IPCN Public Meeting- Gunnedah

Orange Grove Solar farm

My comments today are in relation to the Department of Industry, Land and Water assessment report, the information that has been used as part of the Environmental Impact Assessment report and Review, this a project of State Significance, the facts need to be correct

Figure 2 Site Layout, Locality and Drainage Features

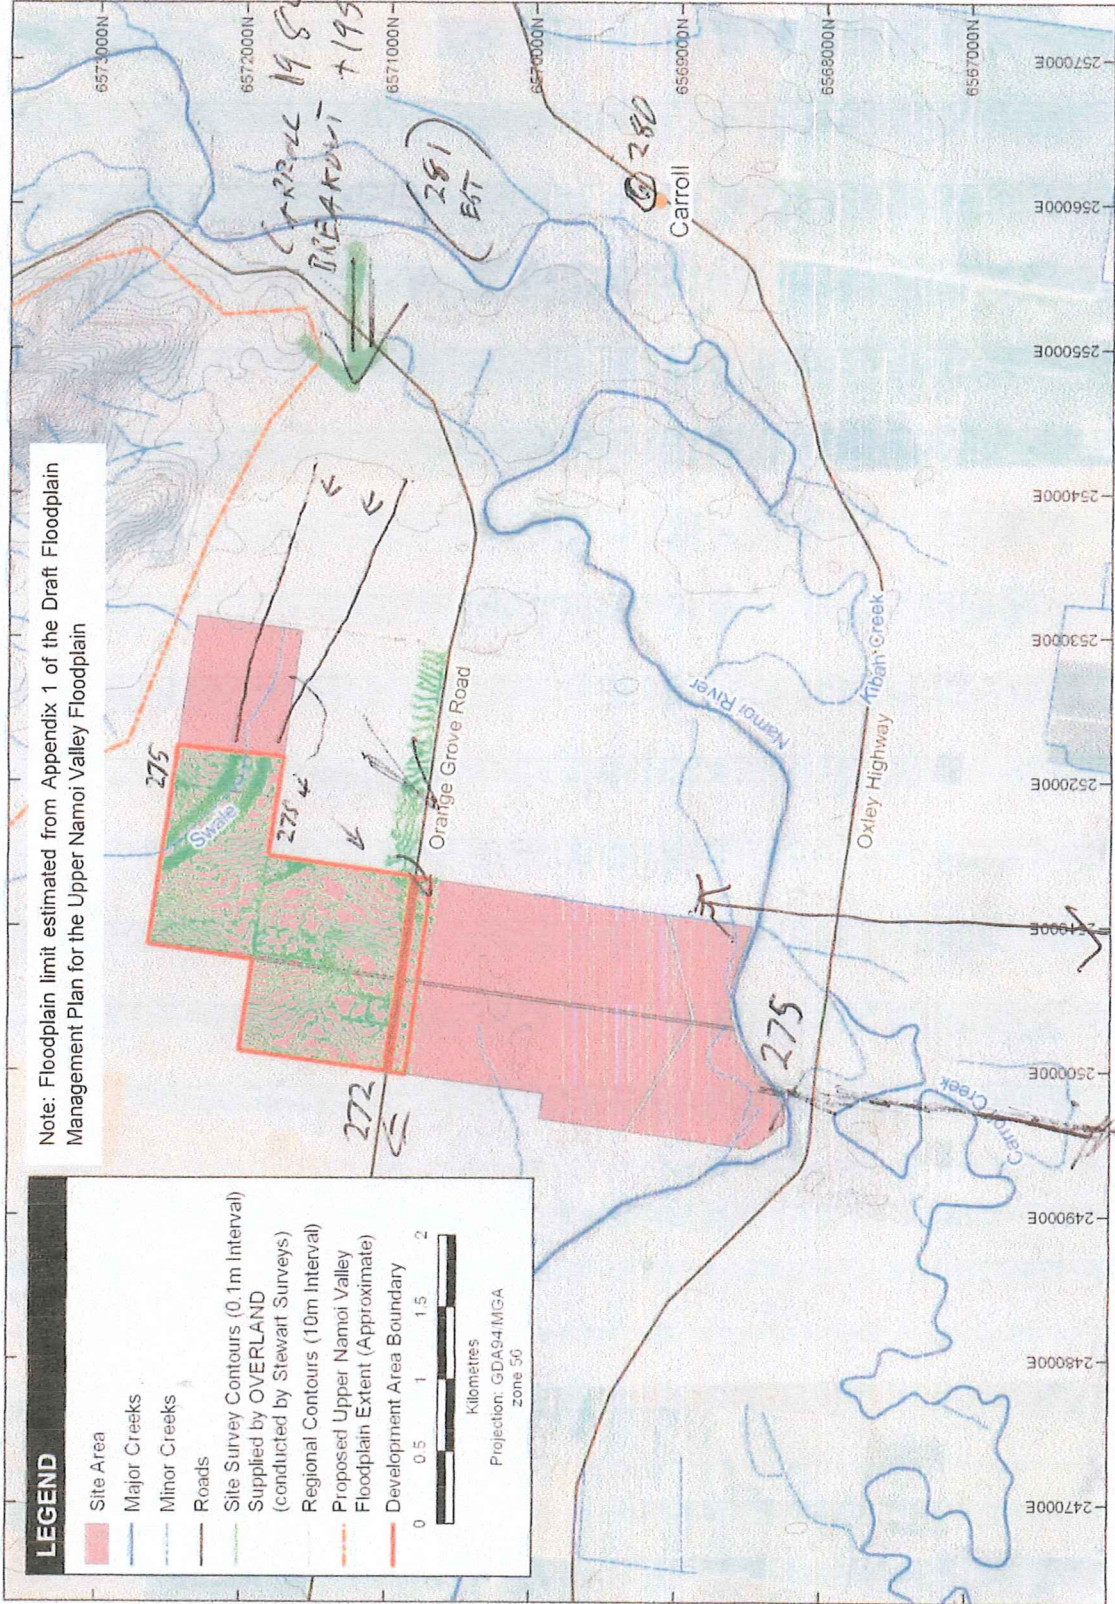
Subsequently as part of response to submissions, a partial reassessment of the floodplain was conducted by another consultant "GHD", GHD quantified that the Swale is actually a breakout channel of the Namoi River. Note that this breakout channel originates east of the proposed solar farm site, which is above the height of the solar farm, GHD showed that there would be breakout flow in a 1984 size flood event

The CBFMP compendium of data estimated that in a 1984 size flood event, that approximately 211 meters/second of breakout flow would occur from the Namoi River above Carroll, towards the proposed solar farm/swale, this breakout has been now confirmed by GHD

Note- that in a 1955 1% AEP type of flood event, the estimated volume (CBFMP) would increase 425% to 897 meters /second, which I would suggest would probably overtop the first order stream and cause the proposed solar farm site to flood

GHD should have modelled and presented floodplain flooding 1% AEP and 3 x 1% AEP extreme event in this vicinity, for this project to be consistent with other Gunnedah Shire state significant developments

These breakout 1984 and 1955 flood flows leave the Namoi river several meters higher than the proposed Solar farm site, the height of the Namoi river in flood is 281 +, AHD above Carroll, Solar Farm site 272.5 AHD, so it is grossly incorrect for HEC consultants to say that the solar farm site is above Namoi River Flood heights.

211 m/s
897 m/s

OVERLAND/STEWART
SURVEY LOCATION?
